**ASHRAE Addendum j to
ASHRAE Guideline 36-2021**

High-Performance Sequences of Operation for HVAC Systems

The purpose of this addendum is to separate the ventilation logic for the Single Zone VAV Air Handling Units (SZVAV AHU) and VAV terminal units in the generic ventilation zones section. As currently written, variables such as V_{min} , unrelated to SZVAV AHU ventilation logic, remain in the generic ventilation sections whether or not they are used.

Revise Section 5.2.1 as follows:

Figure 5.2.1.3-1 V_{min^*} and V_{bz-P^*} reset with CO₂ loop.

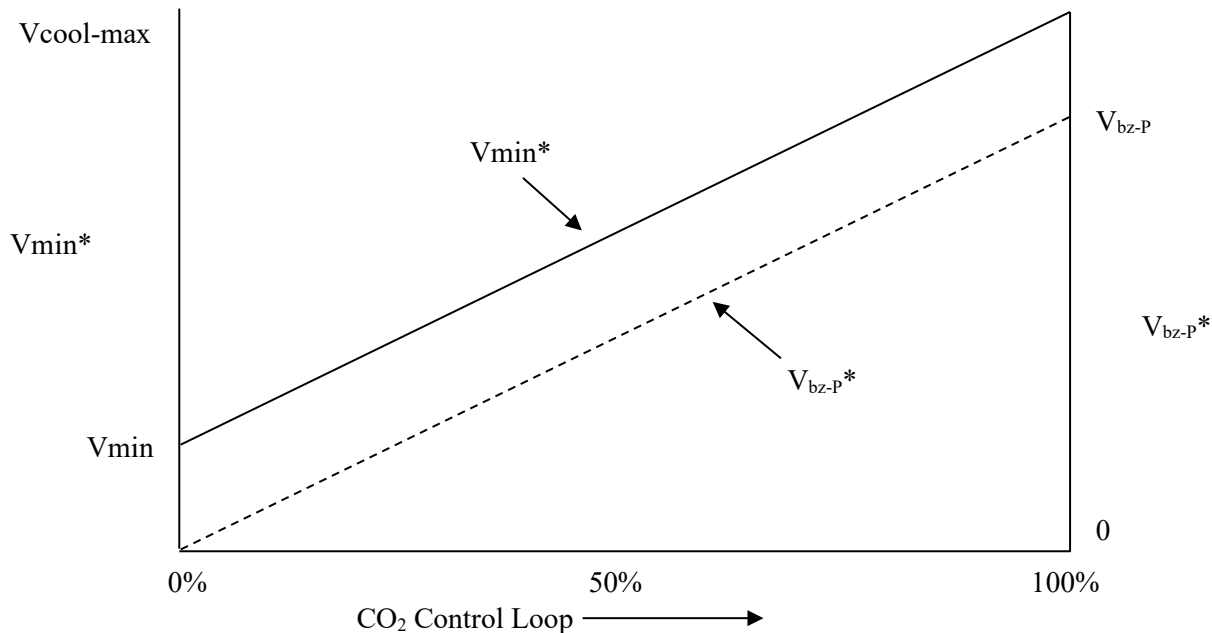
- (d) For cooling-only VAV terminal units, reheat VAV terminal units, constant-volume series fan-powered terminal units, dual-duct VAV terminal units with mixing control and inlet airflow sensors, dual-duct VAV terminal units with mixing control and a discharge airflow sensor, or dual-duct VAV terminal units with cold-duct minimum control:
 - (1) The CO_2 control loop output shall reset both the occupied minimum airflow setpoint (V_{min}^*) and the population component of the required breathing zone outdoor airflow (V_{bz-P^*}) in parallel. V_{min}^* shall be reset from the zone minimum airflow setpoint V_{min} at 0% loop output up to maximum cooling

airflow setpoint $V_{cool-max}$ at 100% loop output. V_{bz-P^*} shall be reset from 0 L/s (0 cfm) at 0% loop output up to the V_{bz-P} at 100% loop output. See Figure 5.2.1.3-1.

Figure 5.2.1.3-2 V_{min}^* and V_{bz-P}^* reset with CO₂ loop (parallel fan-powered).

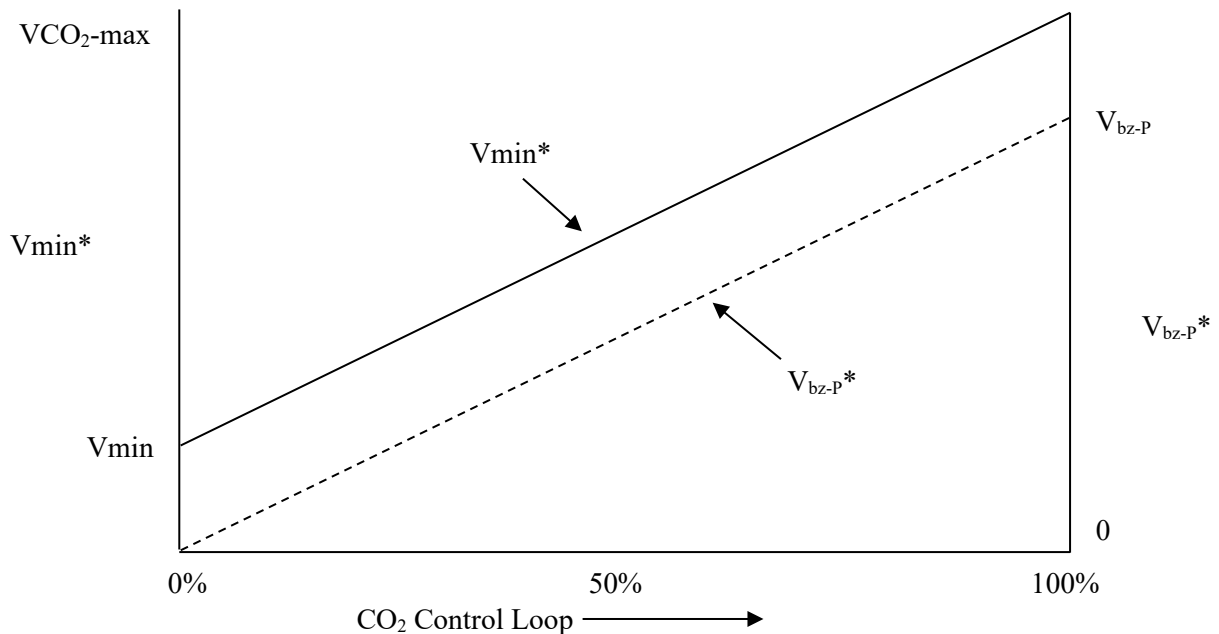
- (4) The CO₂ control loop output shall reset both the occupied minimum airflow setpoint V_{min^*} and the population component of the required breathing zone outdoor airflow V_{bz-P^*} in parallel. V_{min^*} shall be reset from the zone minimum airflow setpoint V_{min} at 0% loop output up to maximum cooling airflow setpoint $V_{CO2-max}$ at 100% loop output. V_{bz-P^*} shall be reset from 0 L/s (0 cfm) at 0% loop output up to the V_{bz-P} at 100% loop output. See Figure 5.2.1.3-2.

Figure 5.2.1.3-3 V_{bz-P*} reset with CO₂ loop (SZVAV).

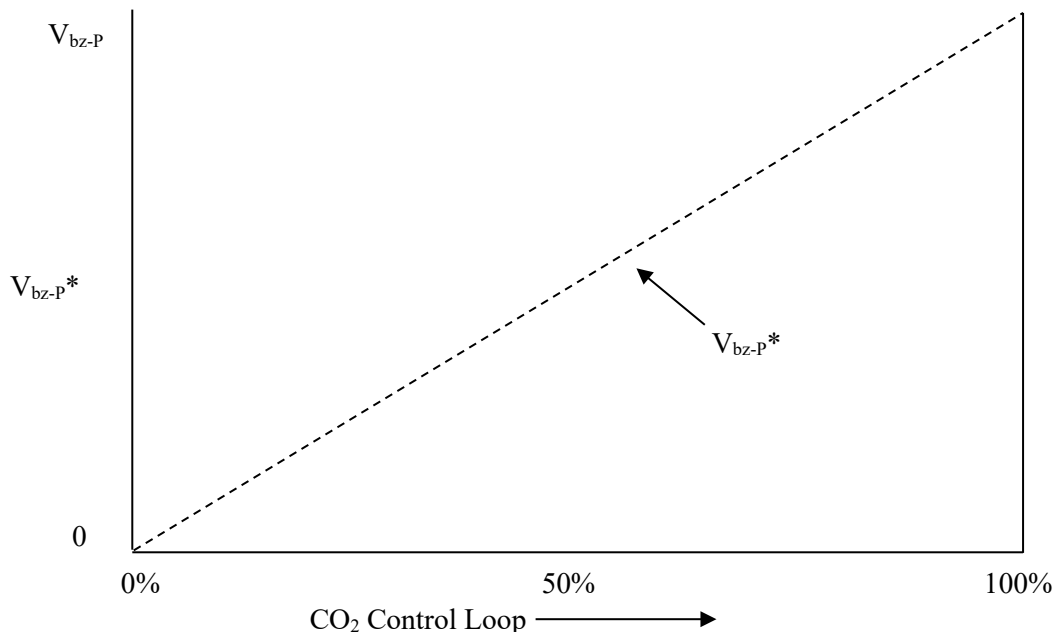
- (d) The minimum outdoor air setpoint MinOAsp is equal to V_{oz}. The CO₂ control loop output shall reset the population component of the required breathing zone outdoor airflow V_{bz-P*} from 0 L/s (0 cfm) at 0% loop output up to V_{bz-P} at 100% loop output. See Figure 5.2.1.3-3.

Figure 5.2.1.4-1 V_{min}^* reset with CO₂ loop.

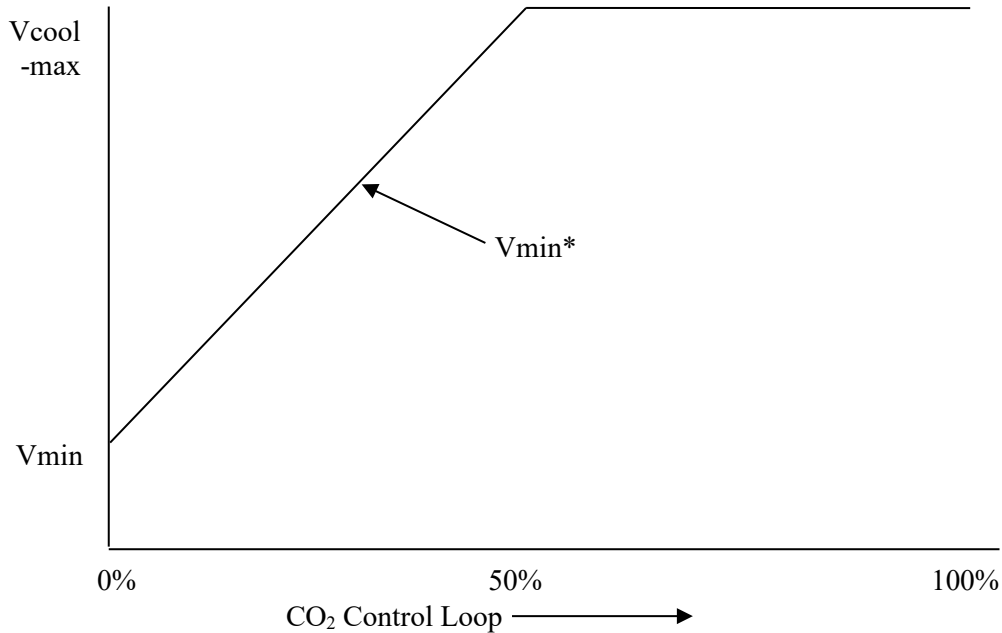
- (1) The CO₂ control loop output shall reset the occupied minimum airflow setpoint V_{min}^* from the zone minimum airflow setpoint V_{min} at 0% up to maximum cooling airflow setpoint $V_{cool-max}$ at 50%, as shown in Figure 5.2.1.4-1. The loop output from 50% to 100% will be used at the system level to reset outdoor air minimum; see AHU controls.

Figure 5.2.1.4-2 Vmin* reset with CO₂ loop (parallel fan-powered).

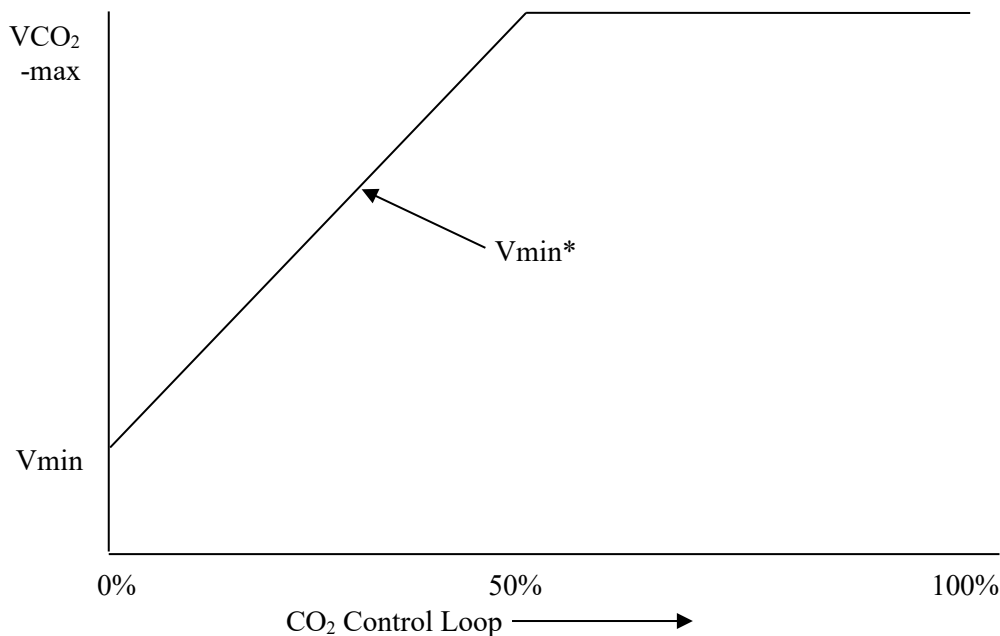
- (4) The CO₂ control loop output shall reset the occupied minimum airflow setpoint V_{min}^* from the zone minimum airflow setpoint V_{min} at 0% up to maximum cooling airflow setpoint V_{CO_2-max} at 50%, as shown in Figure 5.2.1.4-2. The loop output from 50% to 100% will be used at the system level to reset outdoor air minimum; see AHU controls.

Figure 5.2.1.4-3 ~~$v_{min} = \text{MinOAsp}$~~ reset with CO₂ loop (SZVAV).

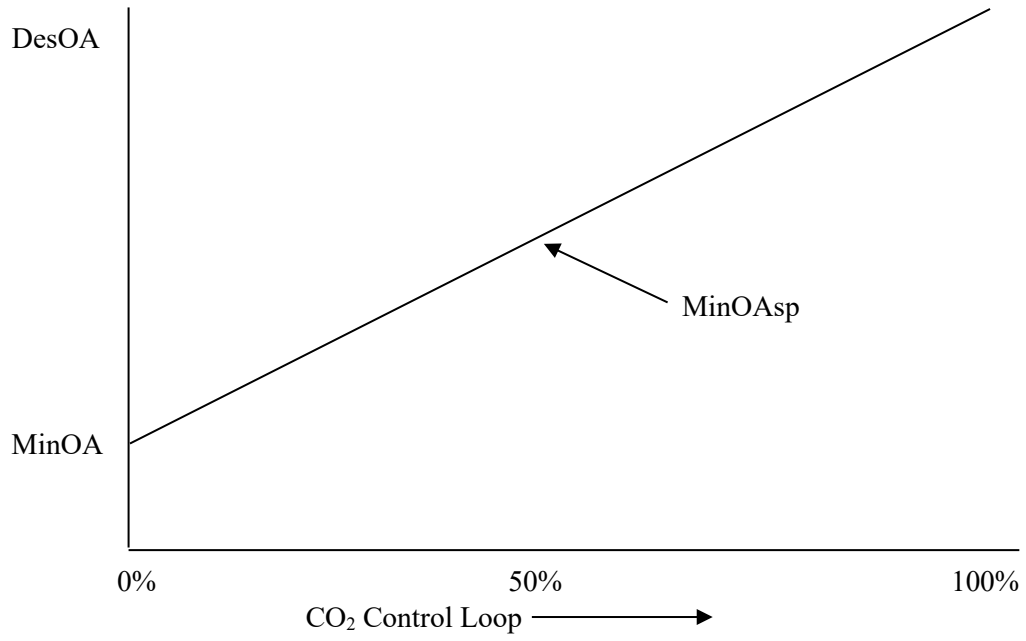
- (d) If the zone has a CO₂ sensor:
 - (1) See Section 3.1.1.3 for CO₂ setpoints.
 - (2) During Occupied Mode, a P-only loop shall maintain CO₂ concentration at setpoint; reset from 0% at setpoint minus 200 PPM and to 100% at setpoint.
 - (3) Loop is disabled and output set to zero when the zone is not in Occupied Mode.
 - (4) The minimum outdoor air setpoint MinOAsp shall be reset based on the zone CO₂ control-loop signal from MinOA at 0% signal to DesOA at 100% signal. See Figure 5.2.1.4-3.
- (e) DesOA otherwise.
